Department of Planning and Zoning

TO: Design Advisory Board
FROM: Scott Gustin
DATE: July 24, 2018
RE: 18-1208CA/MA, 75 Briggs Street

Request: Construct new health club/climbing center. Includes a new building and related site improvements.

PETRA CLIFFS CLIMBING CENTER
75 BRIGGS STREET
BURLINGTON, VERMONT

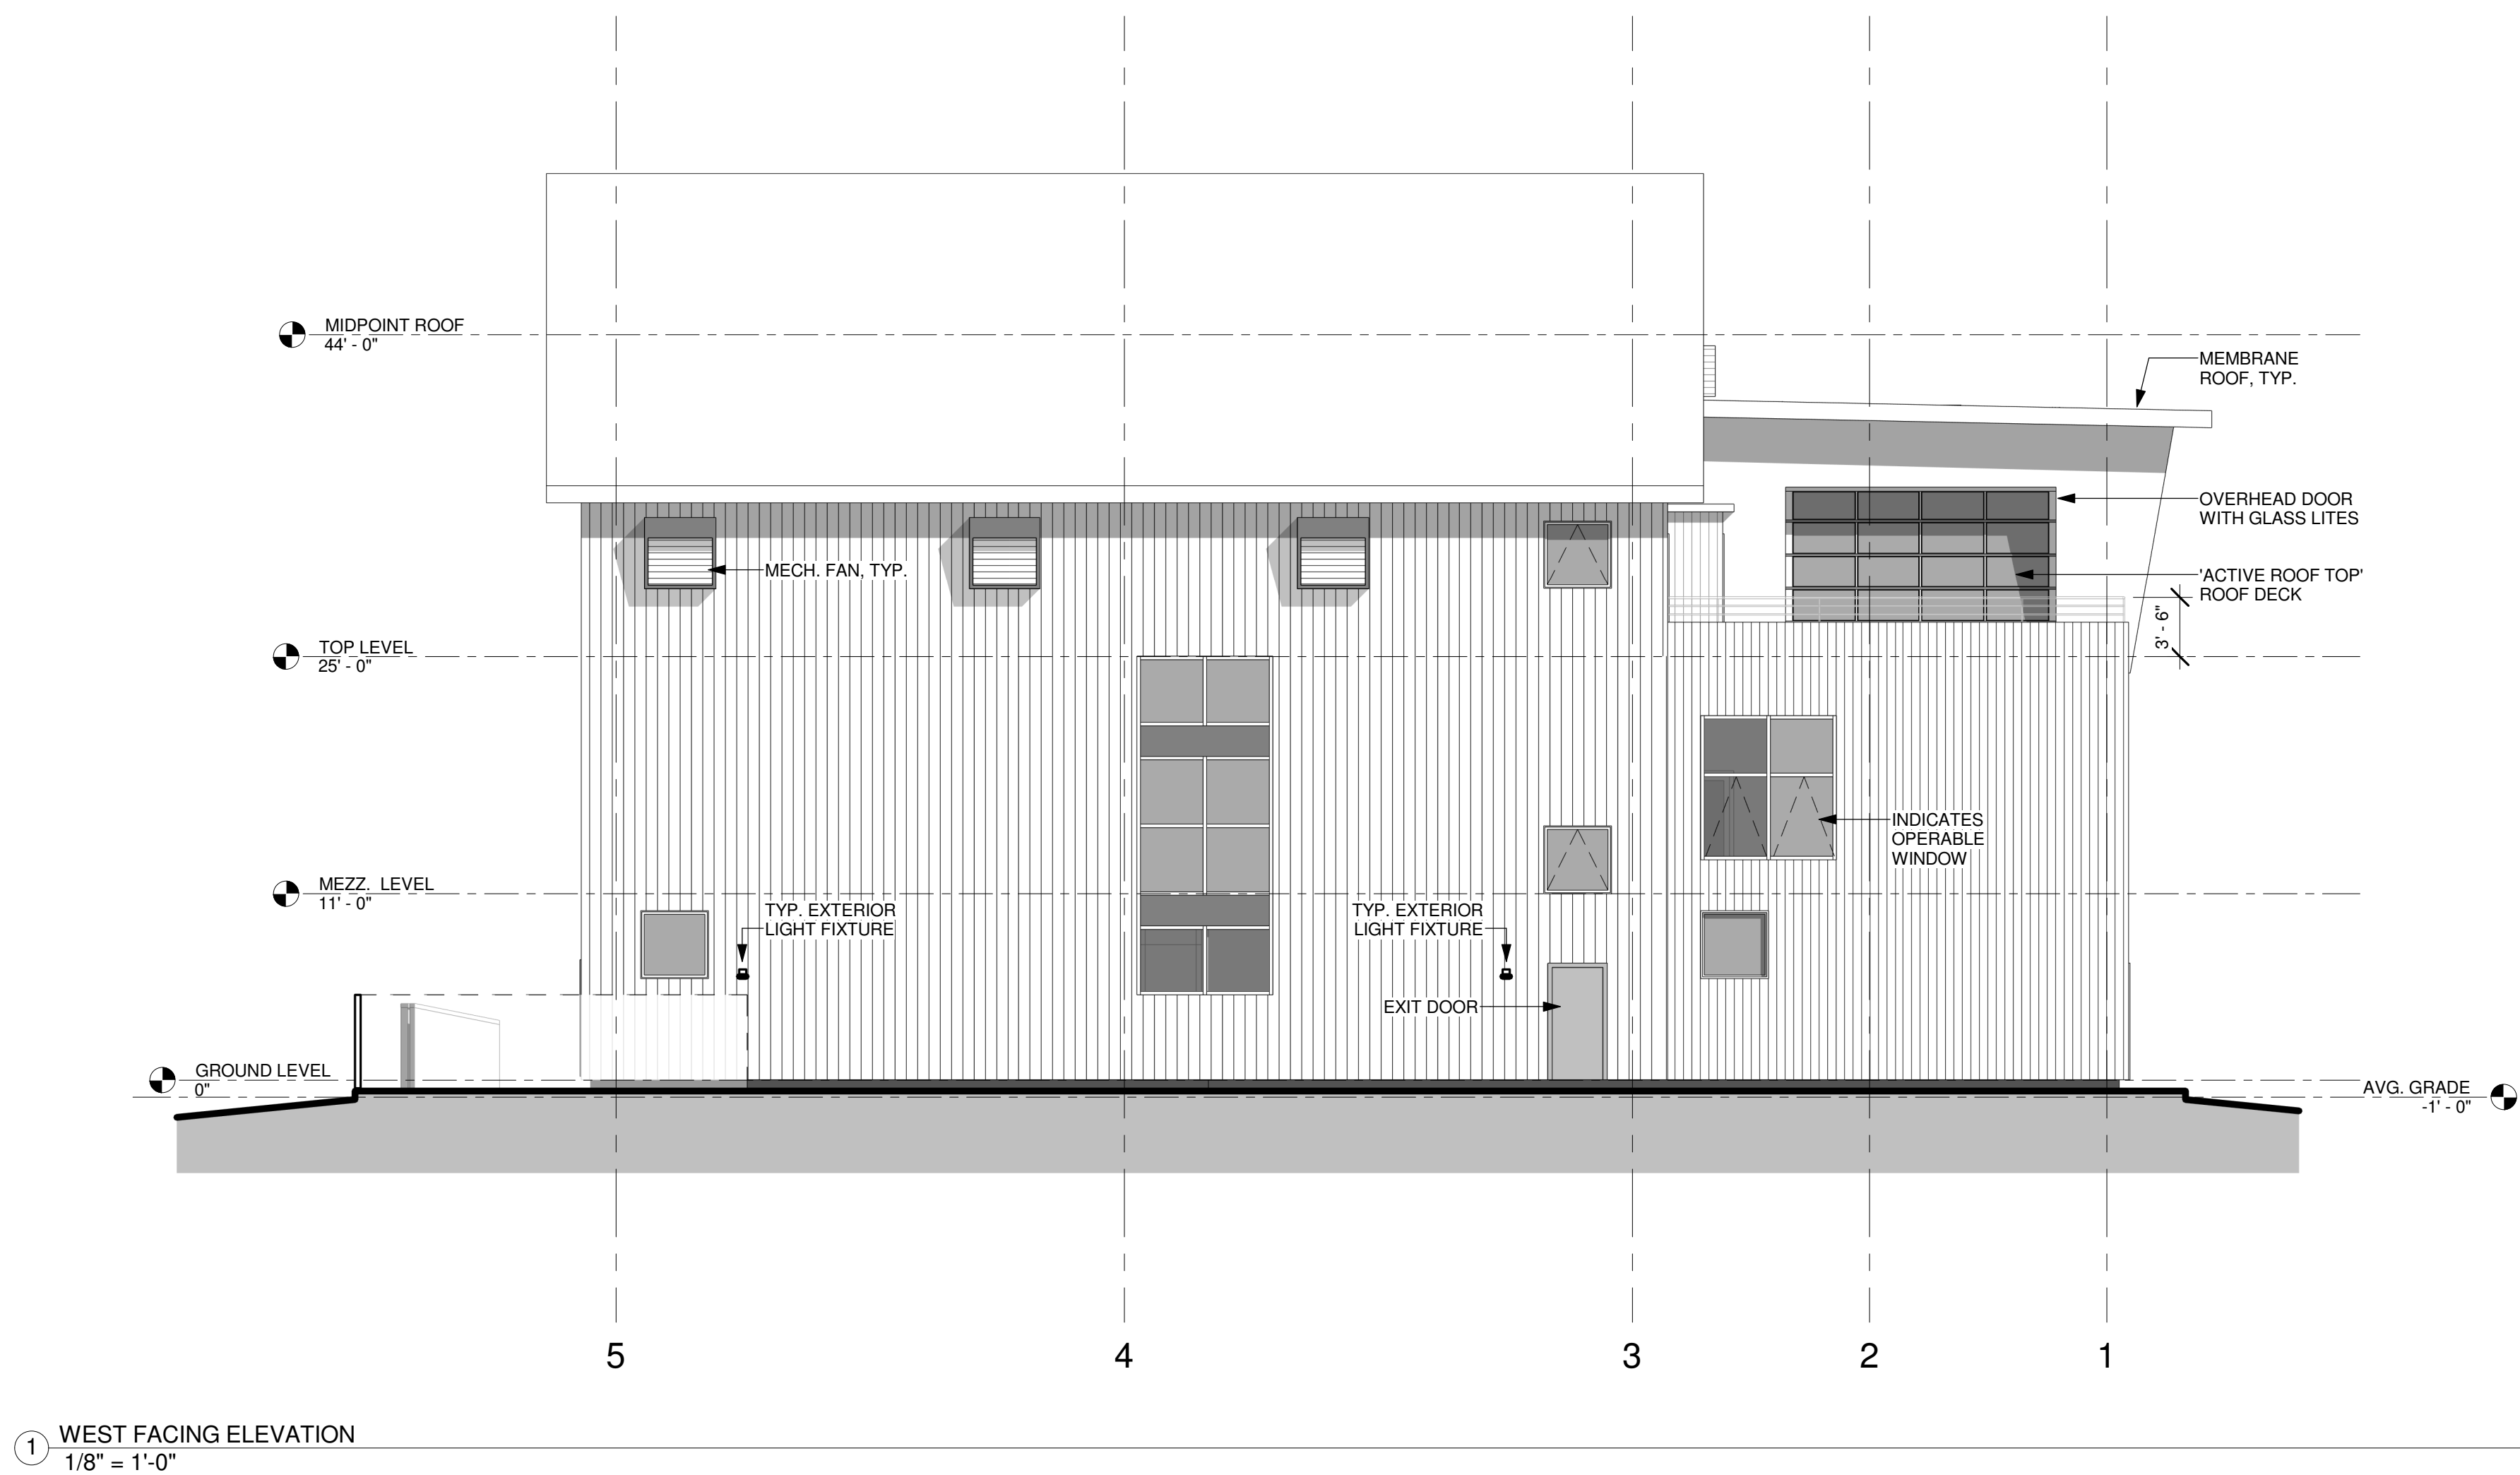
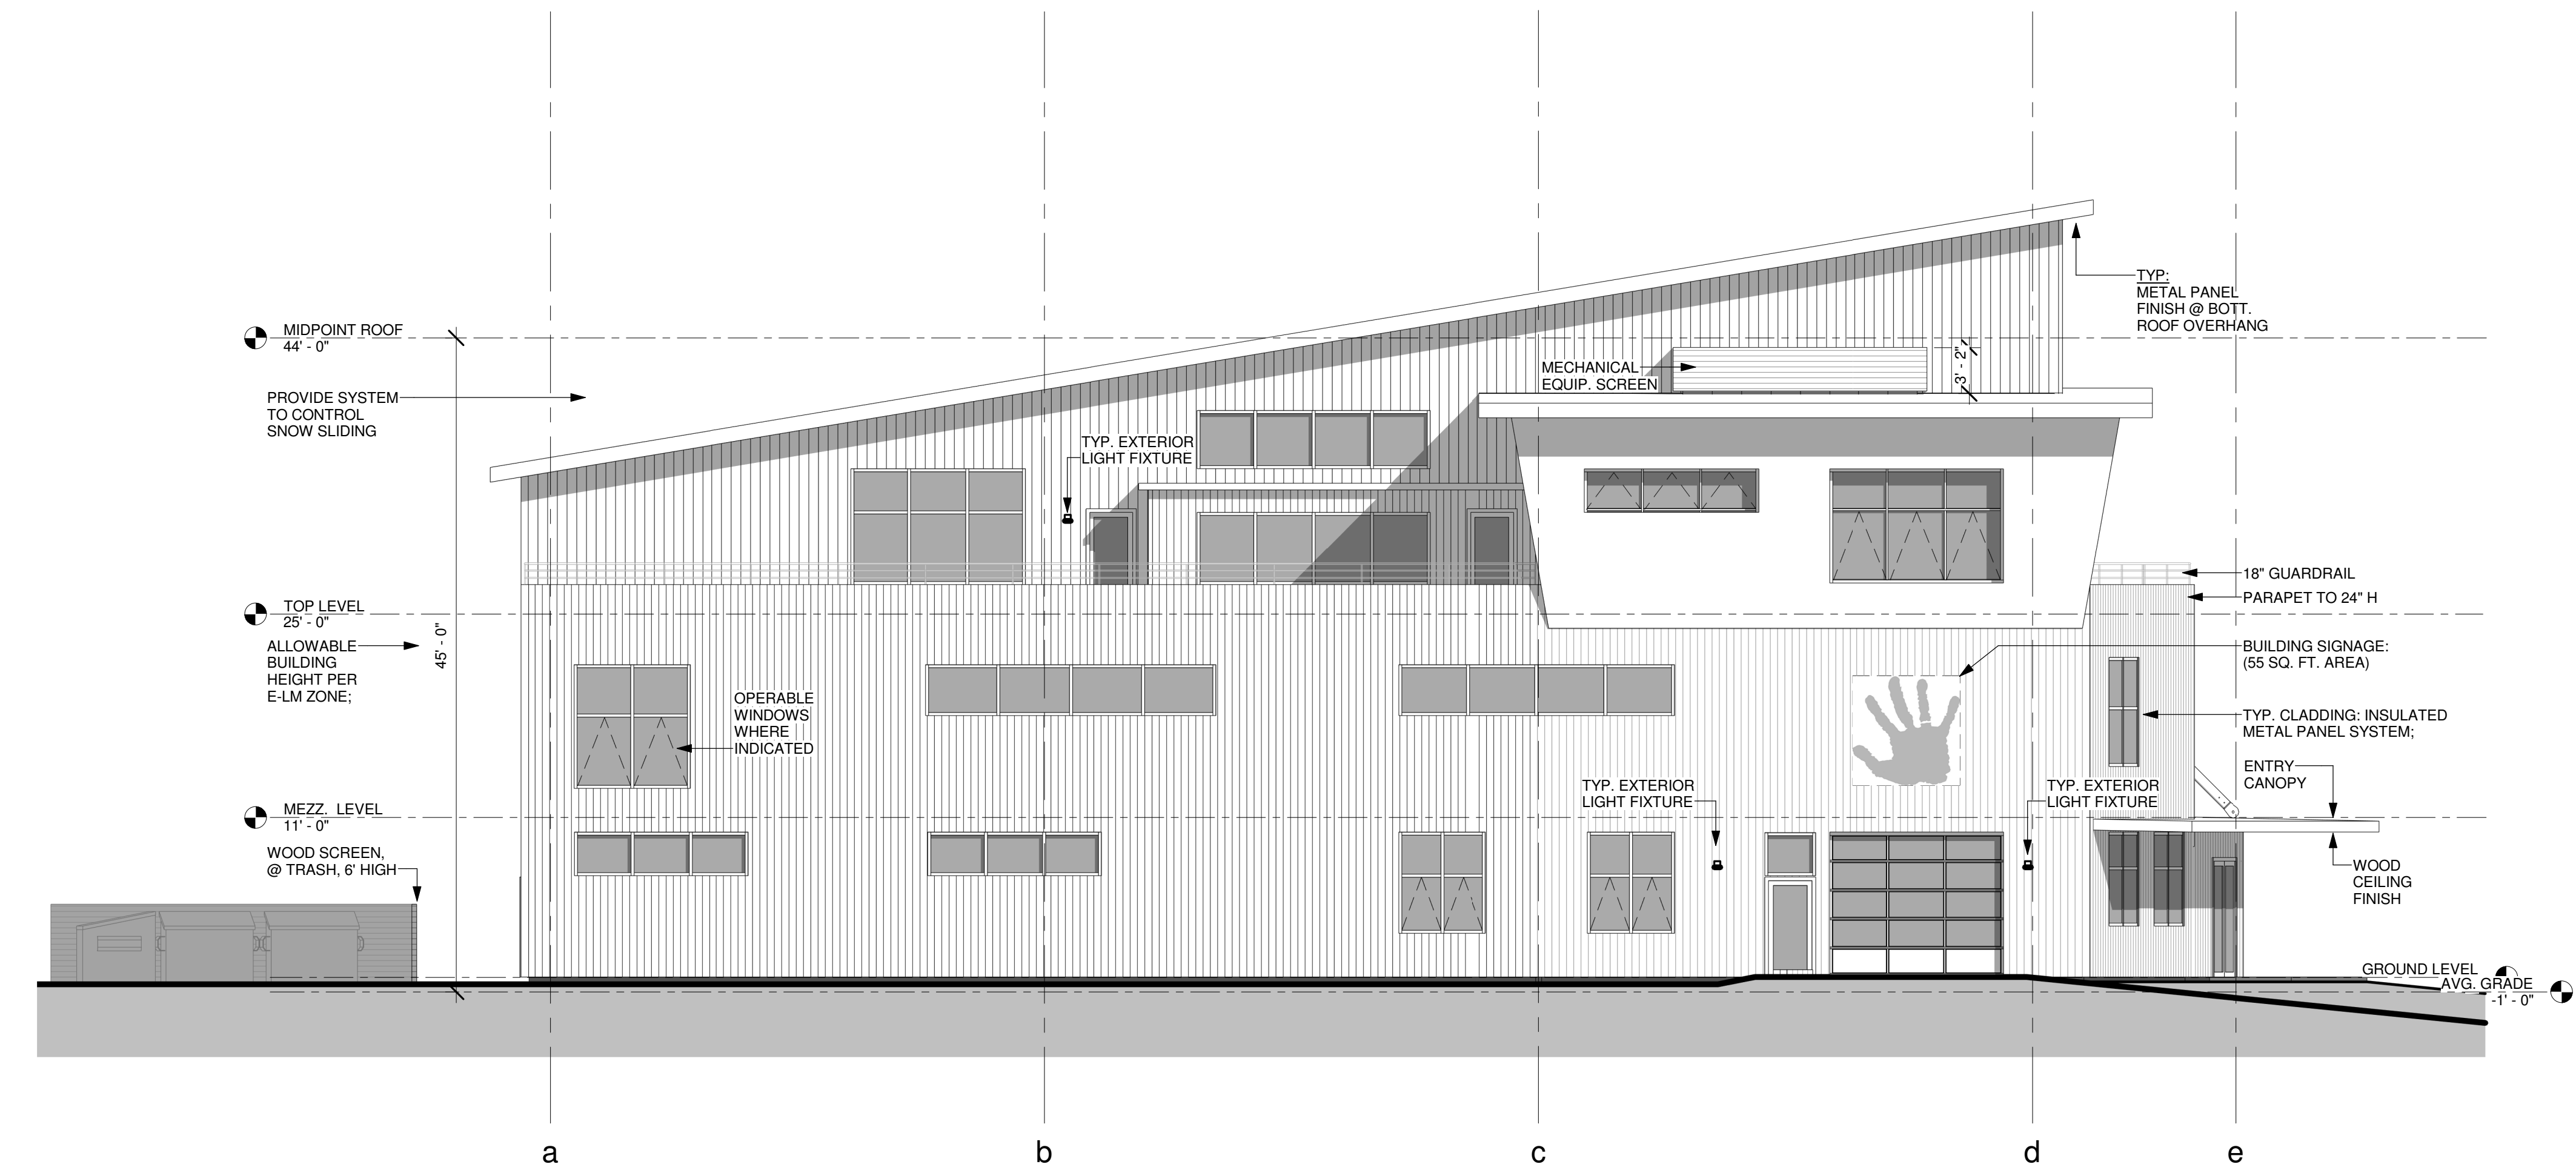
The primary building entrance is sheltered and oriented towards Briggs Street. It is also accessible from the parking area to the south. This primary entrance clearly reads as such. The fenestration is consistent with the angular, boxy appearance of the building. The function of the building's interior as a climbing center limits the placement and extent of fenestration. With that said, additional fenestration has been incorporated into the building's design since sketch plan review and is placed proportionately throughout.

Exterior signs are depicted on the elevation plans. Sign location and area appear to be acceptable. Exterior signage is handled by way of separate zoning permit in any event.
